HISTORIC PRESERVATION COMMISSION

MAY 28, 2020

A. COA-2020-00052

To: Historic Preservation Commission
From: Peter Hughes, Senior Planner
CC: Darryn Burich, Planning and Inspections Director
Kelly Brown, Administrative Specialist
Date: May 20, 2020
Subject: Major COA Request for 335 Linden Road (COA-2020-00052)

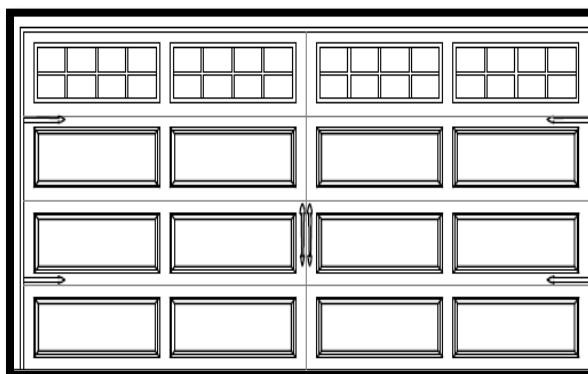
The proposed trim material is MiraTec Trim Boards that will be used for the porch beam, garage and window casings. MiraTec is a composite wood that combines the authentic woodgrain look with the longevity of an engineered product. According to the Historic District Guidelines, the use of engineered wood product on existing structures is permitted, but must not cover other wooden

details. However for new construction engineered wood product is not listed as an appropriate or inappropriate material. The proposed paint color for the trim is high reflective white (SW7757), which is congruous with the Historic District and consistent with the both cottage and craftsman style homes.

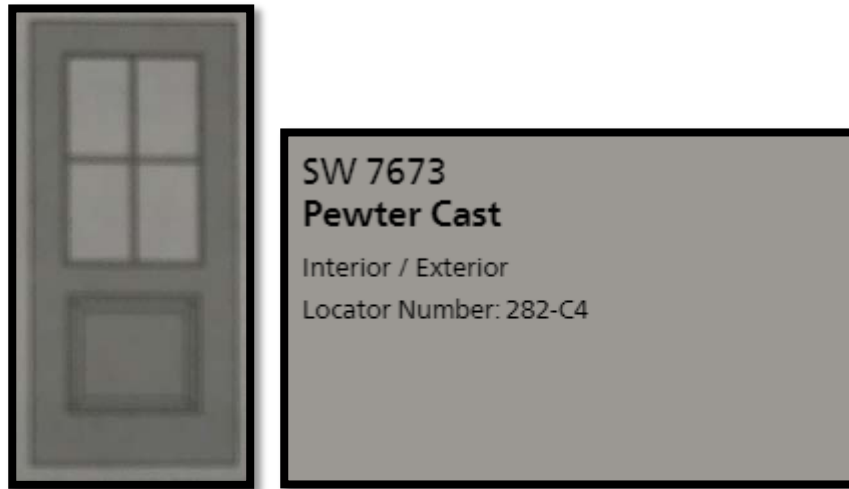
The proposed garage door is a ranch door panel, white in color featuring faux hardware and glass window inserts. The proposed style of the garage door and inclusion of glass windows is congruous with other structures in the Historic District.

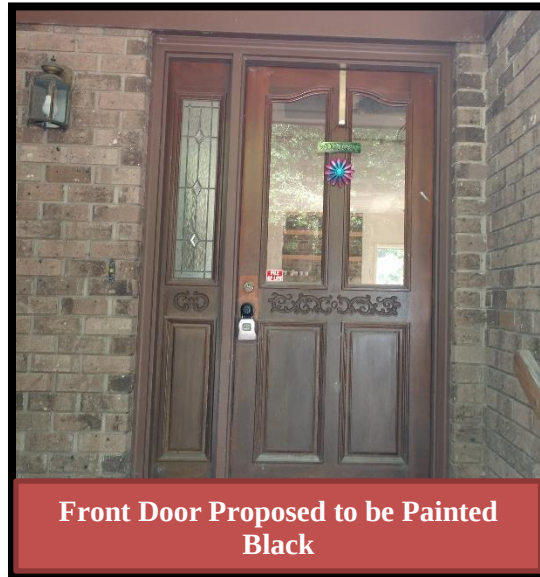
The applicant is also proposing the removal of one window along the right side elevation of the home. The bay window is tucked behind the front façade of the building and is not visible from the public right of way. The window will be removed and then bricked over to match the existing brick of the structure. The removal of this window does not negatively impact the structure, mainly because the window is not visible from the public right of way. The propose removal of the window while not encourage by the Guidelines would be congruous because the change would match existing architectural detail.

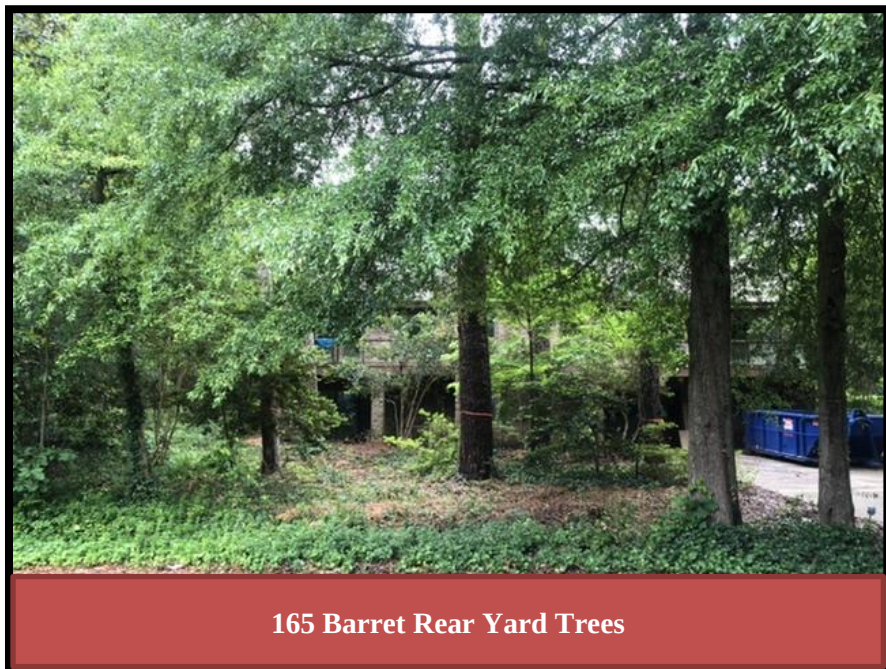
The applicant is proposing to remove multiple trees from both the rear and front yard. 165 Barrett Road is a unique lot with street frontage along both the front and rear. Typically rear yard trees could be removed without HPC approval, however in this case the trees are clearly visible from a public right of way.

The applicant is requesting removal of the tree located in the front because the tree is has started to lean and uproot from the soil and there is concern of the tree falling in the near future.

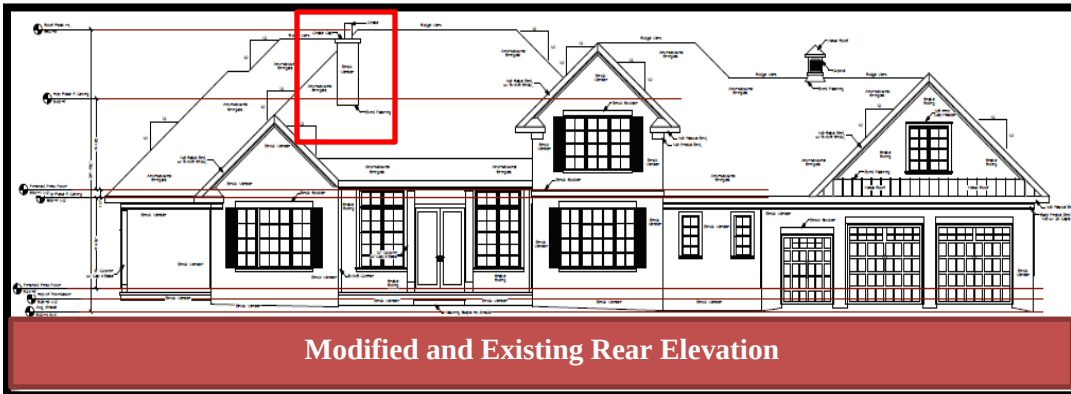
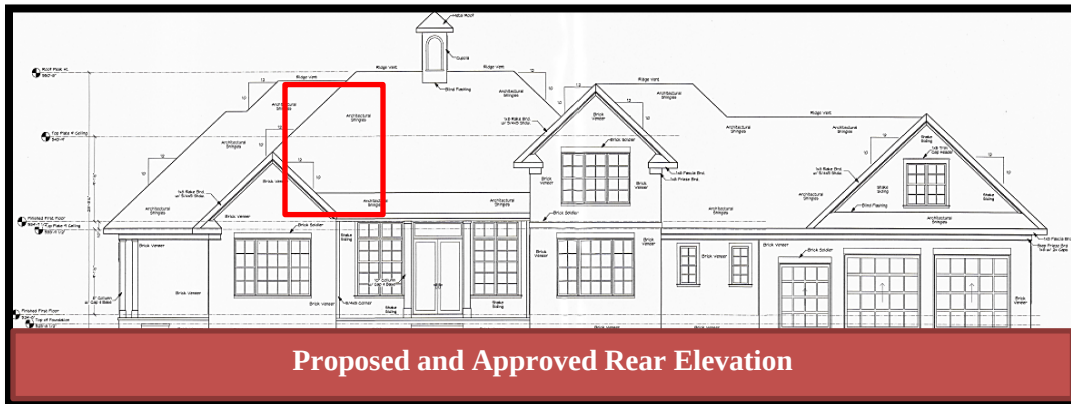
During construction a chimney was added to the rear of the structure. The addition of a chimney adds a distinct architectural detail and additional character to the home. By adding the chimney the applicant did, however modify the approved roofline. The chimney is not visible from the street and chimneys are common throughout the Historic District. While modifications to the roofline are not encouraged, this modification is compatible with the architecture of the structure and does not negatively impact the historic character.

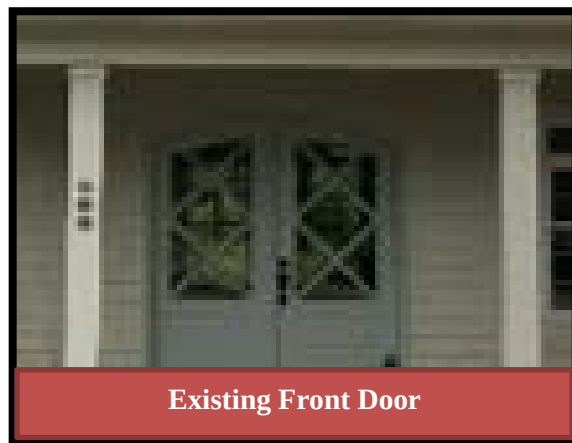
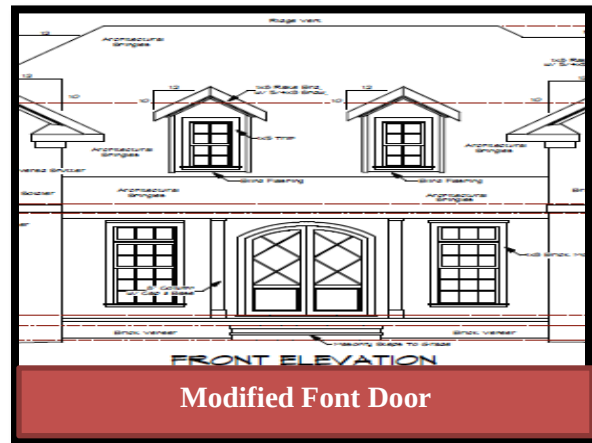
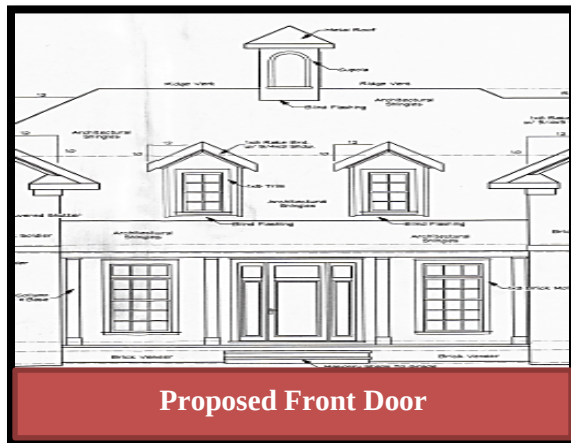
During construction the applicant altered the design of the front door and did not construct the proposed transom windows on the rear elevation.

The commission originally approved a traditional style, wood front door surrounded by transom windows (shown below). The constructed front door is a radius top country French door. The change is not significant, however it was a change that was not approved. The French style door makes the entrance more prominent and adds some diversity to the very linear and square front façade of the structure. This modification is compliant with the historic district guidelines and compatible with the colonial esque architecture.

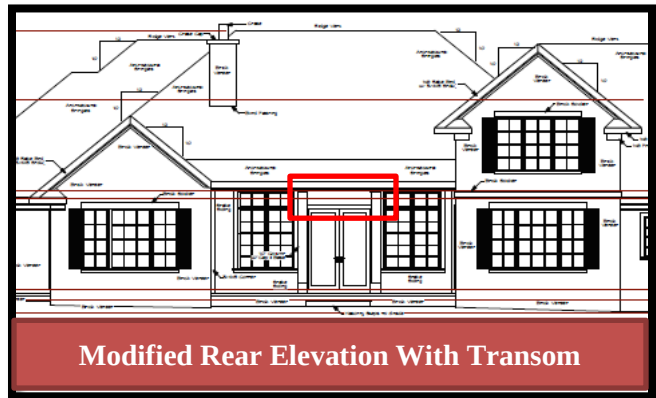
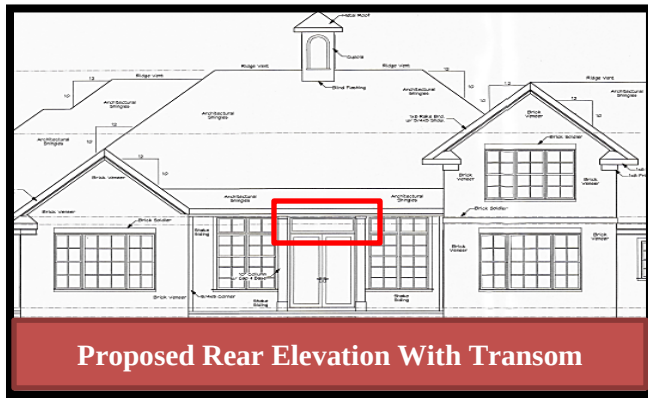
On the rear of the home the approved plans showed the inclusion of a transom window above the French doors on the rear patio. The applicant ending up not construction the transom window and removing them from the design. This elimination of the transom window is a relatively minor modification. Transom windows are a minor architectural detail and the change occurred on the rear of the home causing no effect to the look of the front façade. This is new construction and the colonial architectural design is not lessen without the transom windows.

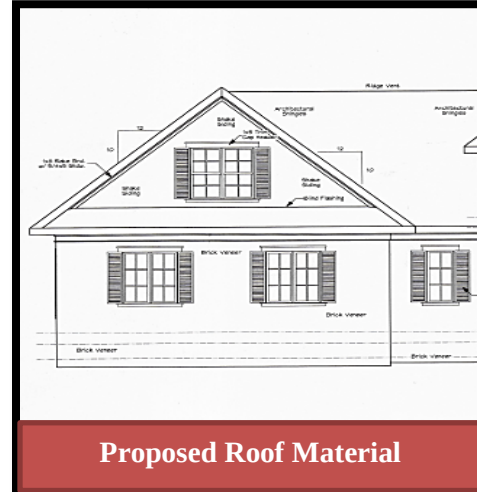
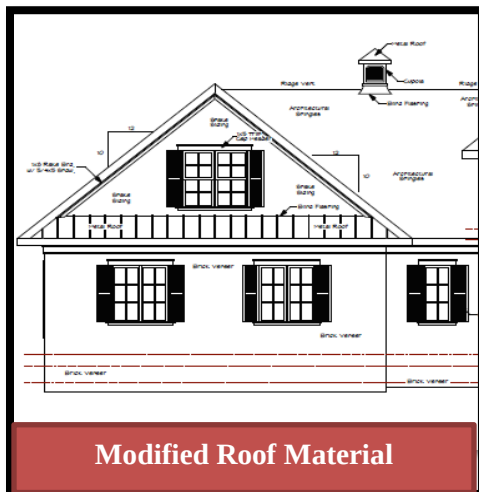
The chimney, which was added during the course of construction is compatible with the existing architecture of the building. The chimney is constructed using the same brick to match the rest of the home and the chimney has the copper flashing surrounding the base, matching the flashing of the rest of the home.
